Corrigendum - 1 dated 29/07/2024 to CPC Tender No. BHEL/CPC/SGL/MPH-CVL/25/023

Corrigendum - 1 dated 29/07/2024 to CPC Tender No. BHEL/CPC/SGL/MPH-CVL/25/023 for the work of “CIVIL AND ARCHITECTURAL WORKS IN FOUNDATIONS & CIVIL SUPERSTRUCTURE FOR MAIN POWER HOUSE BUILDINGS, TG DECKS, COMMON CONTROL ROOM, SERVICE BUILDING, TRANSFORMER YARDS, SWITCHYARD, PIPE/CABLE RACK FOUNDATIONS & MISC. BLDGS. OF UNIT-1 AND UNIT-2 FOR 2X800 MW SINGRAULI STPP STAGE-III, DISTRICT SONEBHADRA, U.P.”.

ROD EARTH ELECTRODE WITH TEST PIT

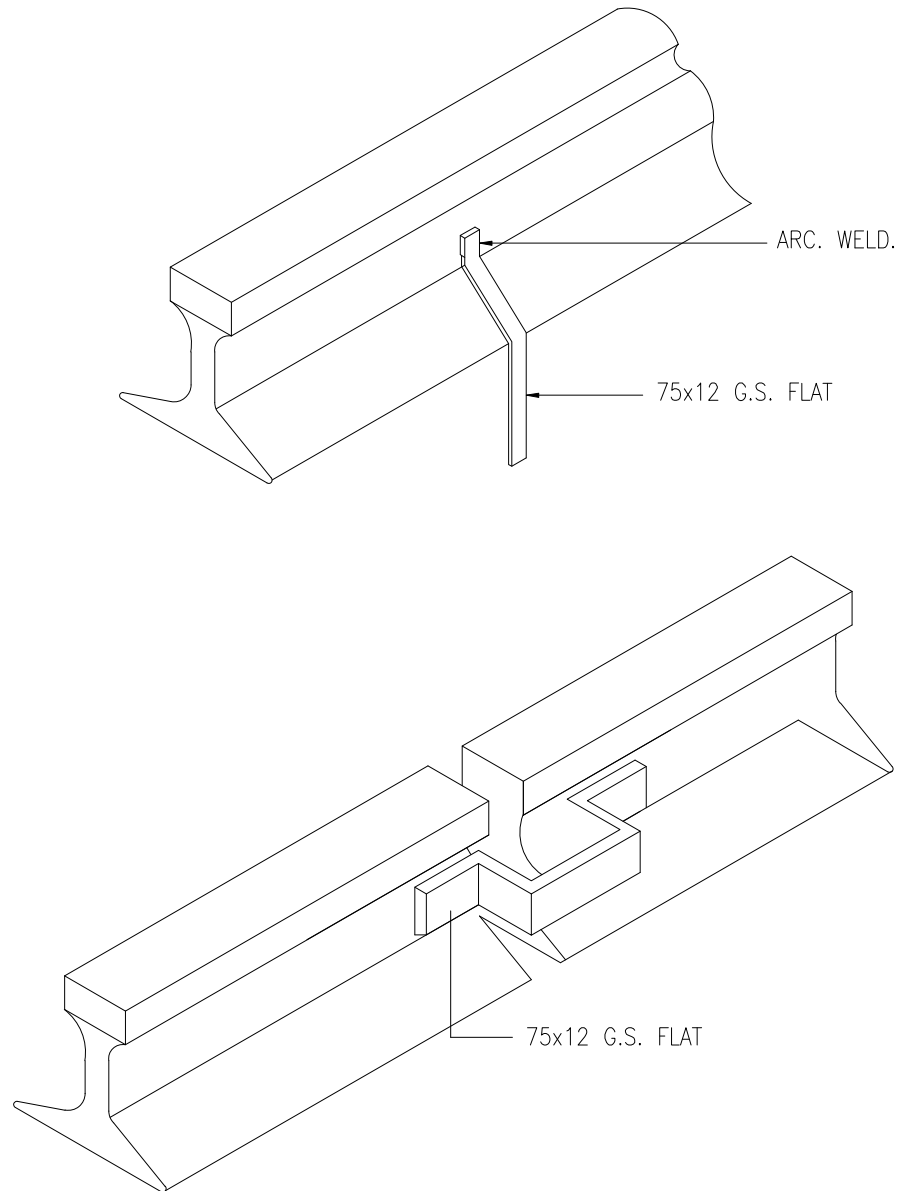
1814B	<p>Installing of 40 mm diameter Rod Electrode with test pit/link per approved drawing including following works :</p> <ul style="list-style-type: none"> - excavation - installing the rod electrode - backfilling and compaction - Casting the Test Pit with Cast Iron covers - any other work necessary to complete the work <p>Note: Only 40 mm Diameter MS rod & test link shall be supplied by BHEL, other items like CI frame, cover etc.</p>	<p>Installing of 40 mm diameter Rod Electrode with test pit/link per approved drawing including following works :</p> <ul style="list-style-type: none"> - excavation - installing the rod electrode - backfilling and compaction - Casting the Test Pit with Cast Iron covers - any other work necessary to complete the work <p>Note: Only 40 mm Diameter MS rod & test link shall be issued by BHEL free of cost, other items like CI frame, cover etc.</p>
1814C	<p>Installing of 40 mm diameter Rod Electrode without test pit/link per approved drawing including following works including following works:</p> <ul style="list-style-type: none"> - excavation/hammering of rod in earth - installing the rod electrode - backfilling and compaction - any other work necessary to complete the work <p>Note: 40 mm Diameter MS rod will be supplied by BHEL.</p>	<p>Installing of 40 mm diameter Rod Electrode without test pit/link per approved drawing including following works including following works:</p> <ul style="list-style-type: none"> - excavation/hammering of rod in earth - installing the rod electrode - backfilling and compaction - any other work necessary to complete the work <p>Note: 40 mm Diameter MS rod shall be issued by BHEL free of cost.</p>

53	BOQ item 1814B	Installing of 40 mm dia Rod electrode Note : Only 40mm Diameter MS rod & test links will be supplied by BHEL.....	Kindly confirm that the MS rod & test links will be supplied by BHEL- Free of Cost . Kindly also confirm the length of the MS Rod Electrode .	Please refere to attached corrigendum-1. Typical Earthing Drawings are attached herewith for bidders reference only. Tender specifications to be followed. Detail drawings shall be provided during detail engineering.
54	BOQ item 1814C	Installing of 40 mm diameter Rod electrode without test Note : 40mm diameter MS rod will be supplied by BHEL .	Kindly confirm that the MS rod will be supplied by BHEL- Free of Cost . Kindly also confirm the length of the MS Rod Electrode.	Bidders are requested to refer Sl No. B) Modification in Technical Conditions of Contract (TCC) and BOQ CUM RATE SCHEDULE ITEMS above.
55	BOQ item A1861	Providing enginering consultancy services for Architectural design & drawings of Central Control Room in Power house building)	Kindly provide the plan area of Central Control Room in sqm for better understanding of scope of work.	Tender specifications to be followed. Detail drawings shall be provided during detail engineering. Please refer TCC Clause No. 2.5.7 and Chapter-VII 'Drawings and Documents' of SCC: Approved construction drawings shall be provided to the sucessfull bidder /
